Proposed Comprehensive Residential and Commercial Development atop Siu Ho Wan Depot
Environmental Impact Assessment (EIA)
Supplementary Information to Advisory Council on the Environment (ACE)

140th EIASC Meeting on 11 September 2017 (Monday) 1

Development Scheme

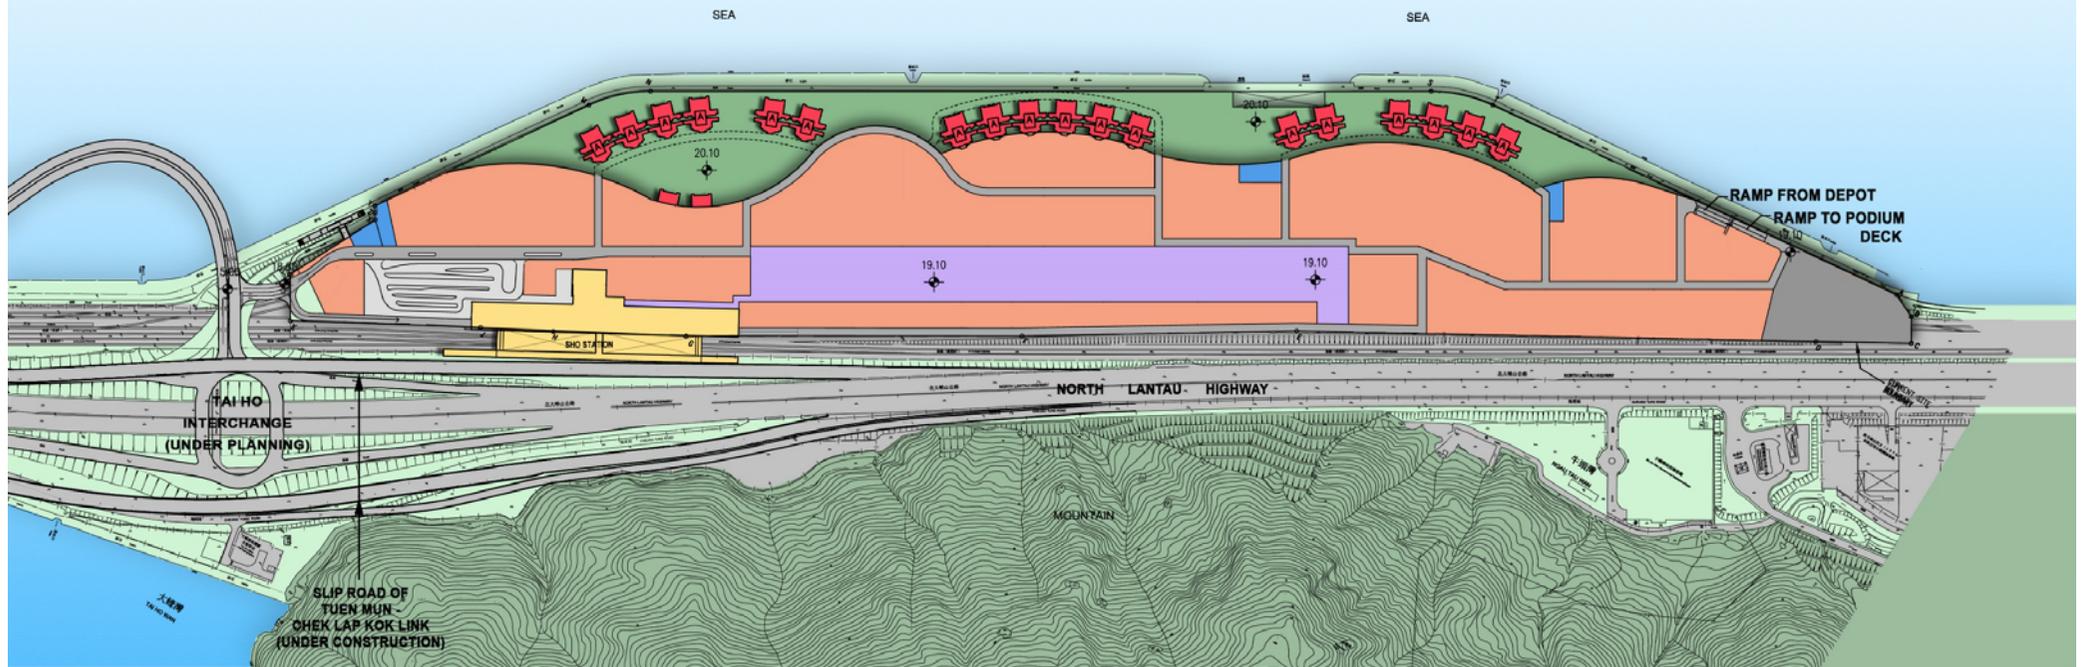
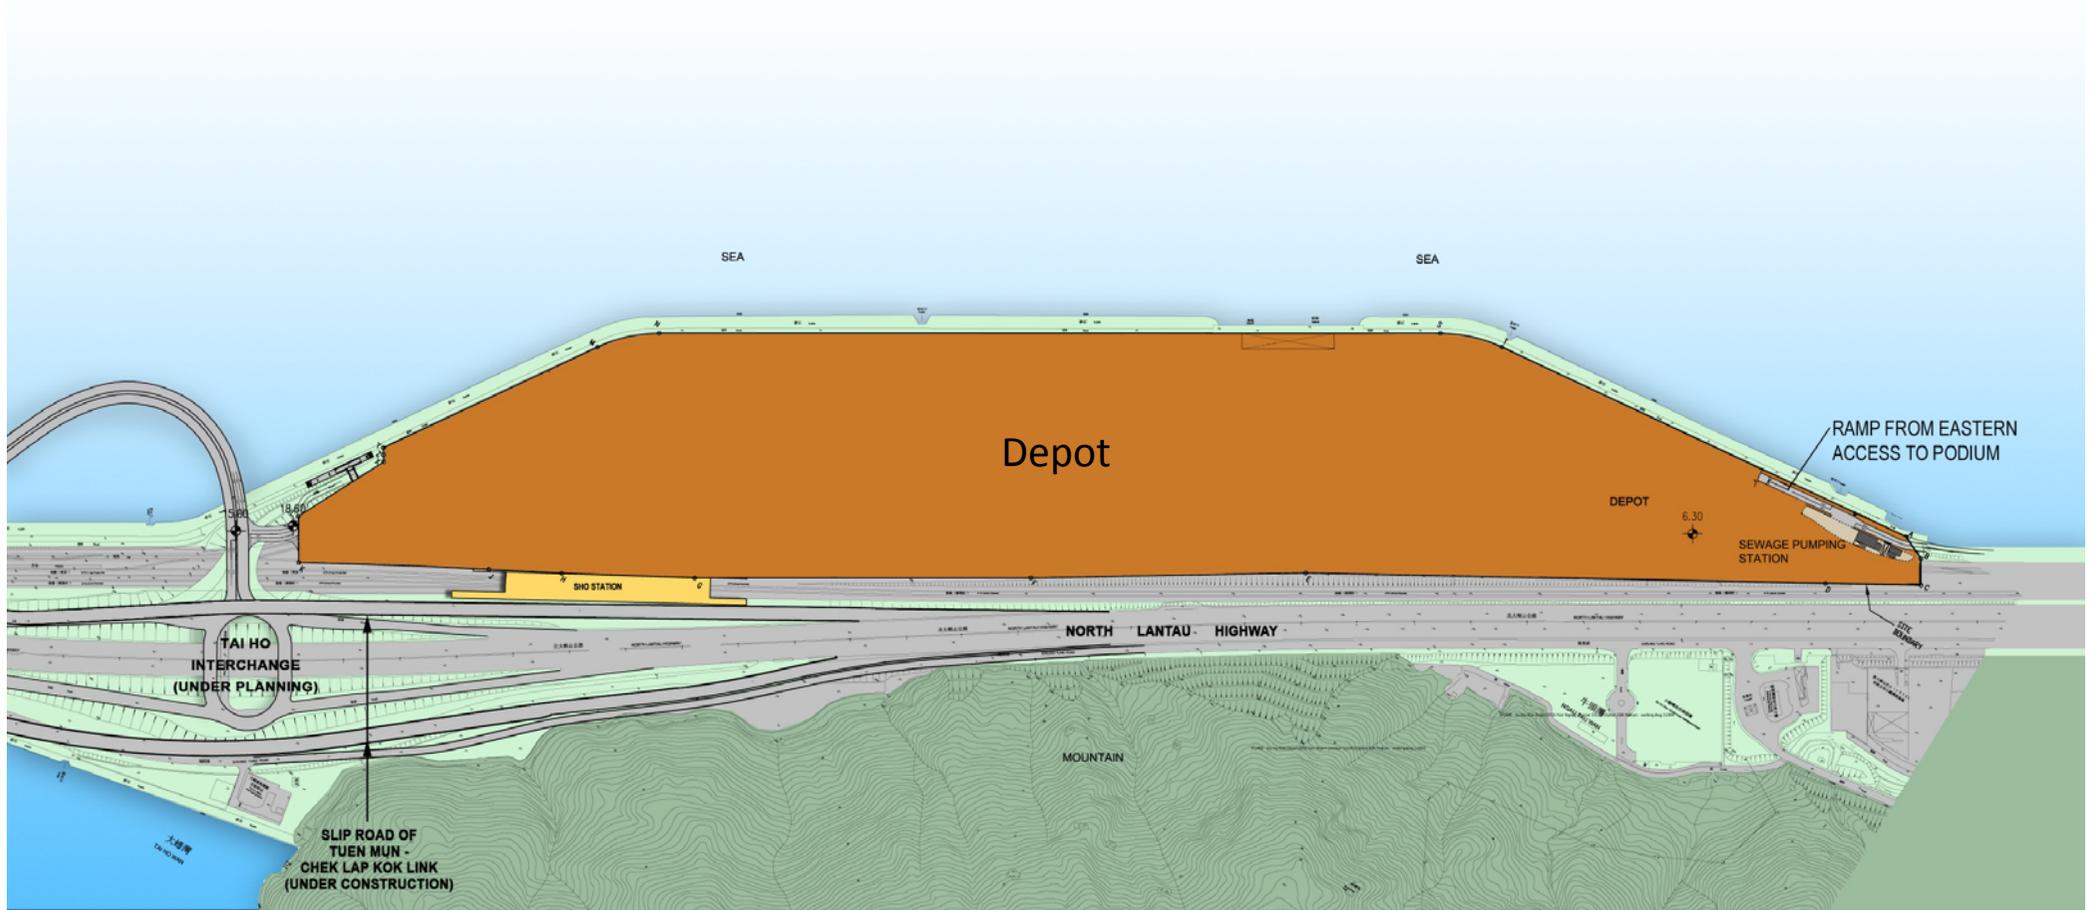
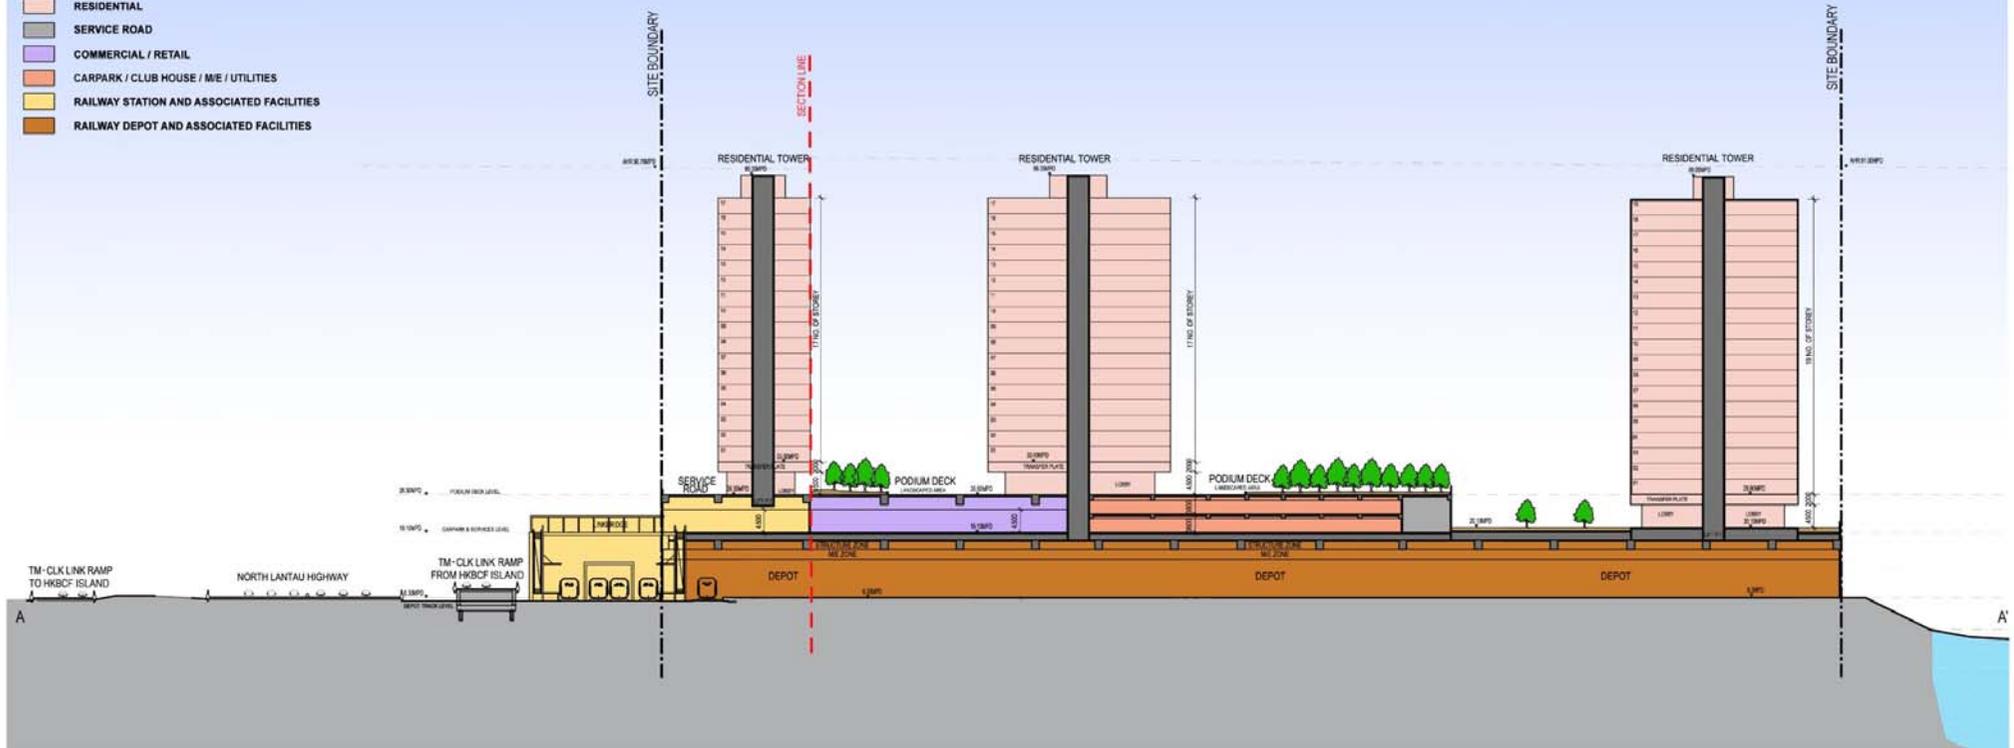
(v)	the master layout plan and relevant sections for the project;	Please refer to section (i) of this document.
(vi)	information on measures that would be implemented for the project to become a sustainable community and low carbon development;	<p>With reference to the Sustainable Design Guidelines promulgated by Buildings Department and the provision of a new MTR station to follow the Transit-Oriented Development (TOD) principle, the topside residential development will be targeted to achieve at minimum the Hong Kong BEAM Plus Gold accreditation to create a low carbon sustainable community. The Corporation also aims at achieving a rating as high as practicable under BEAM Plus (Neighbourhood) during the Master Layout Plan stage.</p> <p>The following green measures will be implemented, subject to detailed design:</p> <ul style="list-style-type: none"> • Electric vehicle charging at all residential and visitor carparking spaces; • High performance building system and equipment, such as low energy absorbent glazing, sunshading, free cooling, air conditioning system and lighting,

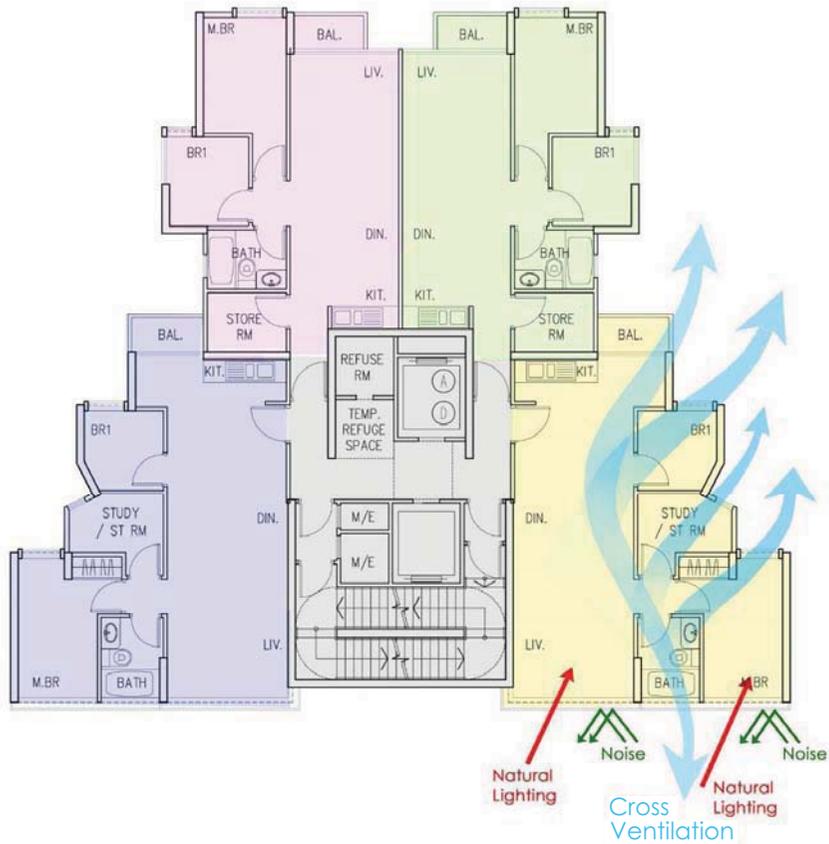
(ii)	feasibility of the project contributing to the waterfront/coastline which is a specific landscape element of the site; providing connectivity of residents to access the northern site boundary and maximizing their use of the waterfront;	<p>In order to maximise the use and enjoyment of the waterfront, the design will provide:</p> <ul style="list-style-type: none"> i) Staircases and lifts connecting the development's podium level with the waterfront ii) A landscaped waterfront promenade along the northern edge of the development's podium level iii) A minimum of 2m setback for the majority of the depot edge along the waterfront for planting of trees, architectural features, green walls and landscaped seating areas in order to create a pleasing and lively backdrop to the waterfront (see Indicative Perspective, Appendix III), iv) Reserved footbridge connection point at development's podium level to the potential Siu Ho Wan Reclamation and/or promenade leading to the Tung

**Elevated promenade
(at podium deck level)**

Connection to waterfront

Figure 1 – Rock Level at SHO Central Location

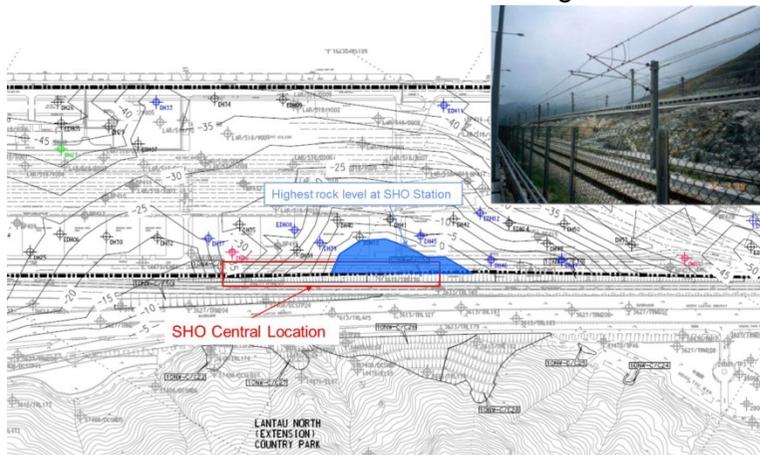
(iv)	detailed explanations on the considerations given to choose the Western Station option instead of the Central Station option;	<p>The key station design considerations and site constraints have been taken into account which included minimizing the disturbance to depot operations, train services and possible risks at the construction of new station, limiting the potential impacts to North Lantau Highway (NLH), Lantau North (Extension) Country Park and Tai Ho Priority Site, construction waste caused by station site formation works, and the transport planning considerations of the future public transport interchange (PTI) and Tai Ho Interchange. Please refer to Appendix V for details.</p>

The central location by extending the TCL tracks at the side of the shared tracks was studied and it has the following issues:

- The platform of the station under this option will be located at the tracks which are being share-used by TCL/AEL and longer additional TCL tracks modification would be required.
- Considering station platform has to be on flat level, extensive site formation works would need to be conducted in the vicinity of the operating tracks at the central location for Central Station option. The hard rock located at the location of Central Station will induce extra difficulties and great risks to the modification works next to the live tracks with both AEL/TCL running at over 130kph at this location. The extensive site formation works which would result in higher construction waste is also considered to be less environmental friendly.

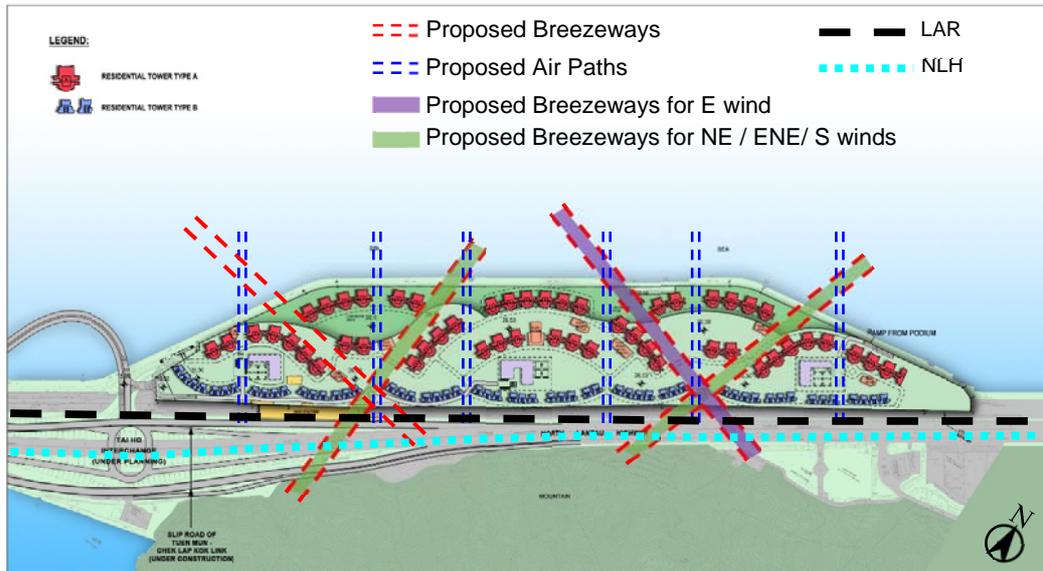
(vii)	<p>information on air ventilation assessment, microclimate study and view study done to justify the locations of the breezeways/airpath and view corridor;</p>	<p>The breezeways/ local air paths and visual corridors are planned at strategic locations that were technically assessed through qualitative air ventilation and visual assessments. These technical studies found that such strategic locations would enhance air ventilation and visual permeability across the Project Site which would lead to least adverse impact to the surrounding area.</p> <p>An Air Ventilation Assessment (AVA) - Expert Evaluation (EE) Report was prepared and had been submitted and reviewed by Planning Department. The AVA-EE was conducted based on the prevailing wind directions under annual and summer wind conditions based on the available wind data and windroses (including RAMS published by PlanD, measured data by HKO and the Site Wind Availability Study of an adjacent planned Tung Chung East. The AVA-EE had confirmed that two of the</p>

Given the shape of the Project Site is elongated which oriented in ENE-SSW direction, diagonal orientation of breezeways are proposed. Four 30m-wide breezeways are proposed. With the funnel-like building arrangement near two ends of proposed breezeways, more wind would enter the proposed breezeways. However, the presence of Lantau North Country Park to the southeast would predominately limit the wind availability to the Project Site. Upon the qualitative discussion on the wind performance on each group of prevailing wind directions identified, the performance of each proposed breezeways would vary:

- Two of four proposed breezeways running in N-S directions (highlighted in Green) would be more effective in allowing NE, ENE and S winds to travel along;
- One of four proposed breezeways running in E-W directions (highlighted in Purple) would be more effective in allowing E wind to travel along.

Six 15m-wide local air path running in NW-SE (Blue dotted lines) are the visual corridor which would also act as local paths that supplement the air flow within the Proposed Development.
